# **NRC Public Meeting on NTTF 2.1 Seismic and Appendix H to NEI 12-06**

**October 21, 2015**

# Update on Appendix H to NEI 12-06

# Path 4 NRC Comment Responses

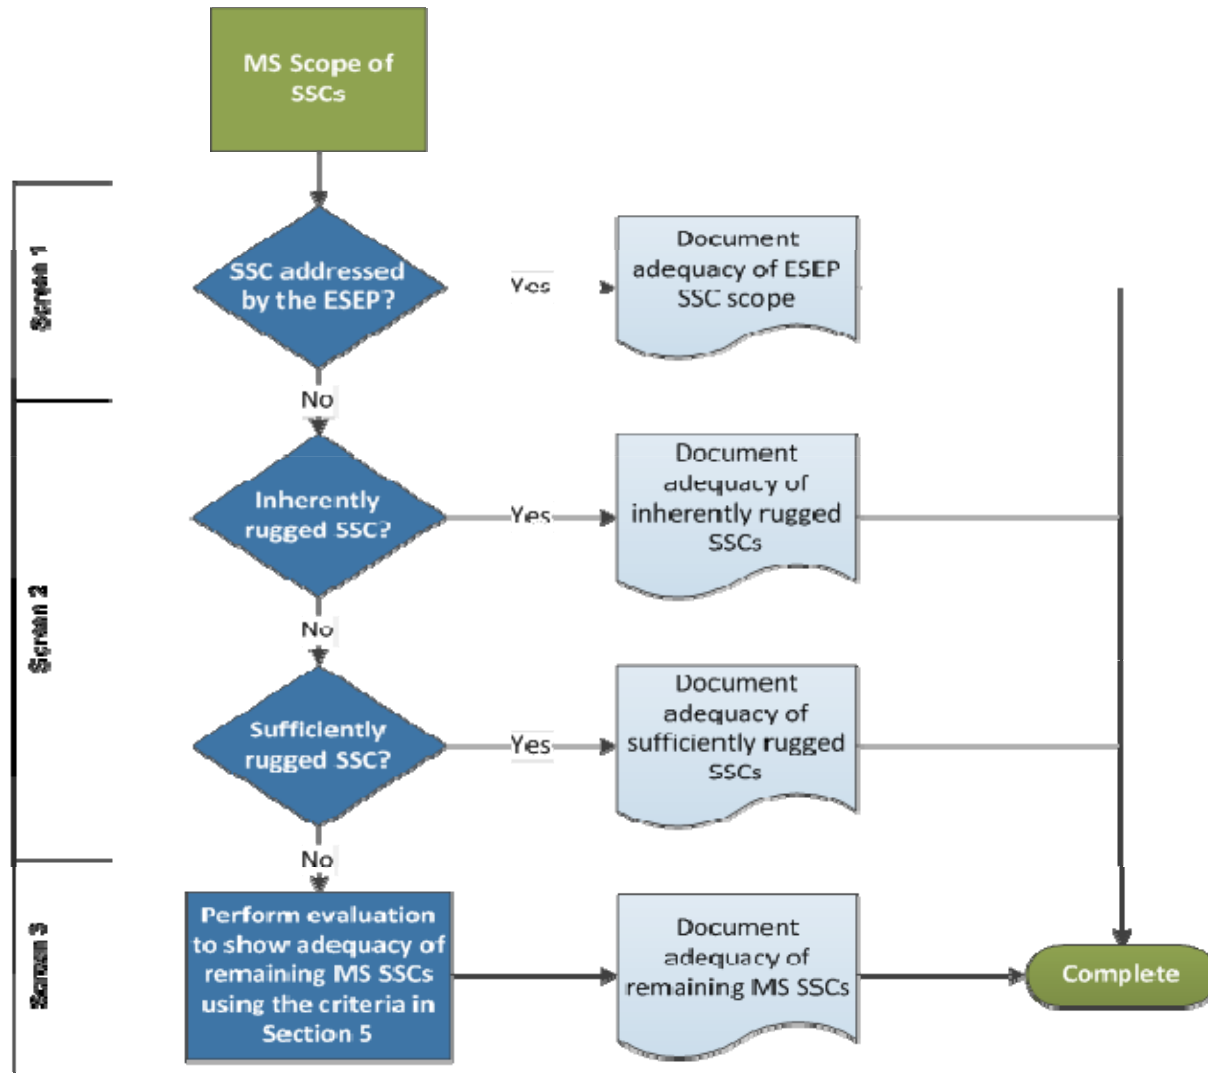
**Comment 24.** Page 8, third sentence under “Basis:” It is important to point out the limitations of the ESEP and why it was done to provide an overall context for the scope of this evaluation. The ESEP was developed as an interim evaluation so that more time taken to perform the SPRA. The scope of the ESEP was intentionally limited to meet expedited schedules. Therefore, these evaluations will have to address the omissions in the ESEP and supplement with new evaluations for SSCs and other aspects of mitigating strategies that have been not evaluated to the new seismic hazard.

- Discussion added “The ESEP was an interim evaluation and included a review for all potential failure modes with one exception associated with seismic interactions. The ESEP included the reviews of seismic interactions associated with block walls in the vicinity of the ESEP equipment and for differential displacement type interactions for tanks. As such, any additional seismic interaction failure modes affecting the ESEP equipment would need to be considered as part of the MSA. Outside of these additional seismic interaction reviews, no further work is required to demonstrate the reasonable protection to withstand the new seismic hazard for those SSCs that were within the scope of the ESEP.”
